Section 4 comments from Ballot on Draft Standard D2 (Vic Hayes, Chair, AT&T WCND)

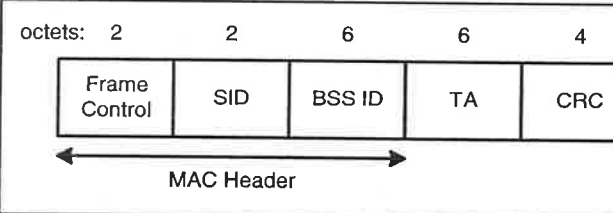
4.1.2.4.3	BD	T	N	<p>re BSSID: In an ad hoc LAN, this field shall be transmitted with the BSS ID of the ad hoc network. The value of this field, in an ad-hoc LAN, shall be the MAC address of the STA</p>	<p>The use of the initiating station SA as the BSSID raises a question - consider the following sequence: STA A starts and IBSS to talk to</p>

<p>that initiated the ad-hoc network.</p>	<p>STA B and C. The BSSID for this IBSS will then be A. Consider what happens when A leaves the IBSS - the BSSID stays "A". now suppose STA A wants to start an IBSS to talk to STA D (in the same location as B and C) - what happens? Does the 2nd IBSS set up fail? Prob not, but this is the join vs create discussion, joining may not be what the station intended.</p> <p>Do you get two IBSSs with the ID=A? No, D2 implies that A joins the existing A IBSS.</p> <p>Is this desirable or not? If they all collapse into one IBSS called A, I hope people understand the danger of using BSS/ESS wide shared keys - B and C will be able to hear the traffic between A and D - in many cases this may not be at all what A desires.</p> <p>The fundamental problem is that 802.11 deals with a shared medium, hence it has had to include notions of logical rather than physical LANs (ESS and multiple IBSSs), but has not provided sufficient control mechanisms to allow PDUs to be delivered to/from a specific logical LAN. I suspect that what is needed is additional information passed into the MAC on a per MSDU basis which identifies the logical LAN the</p>
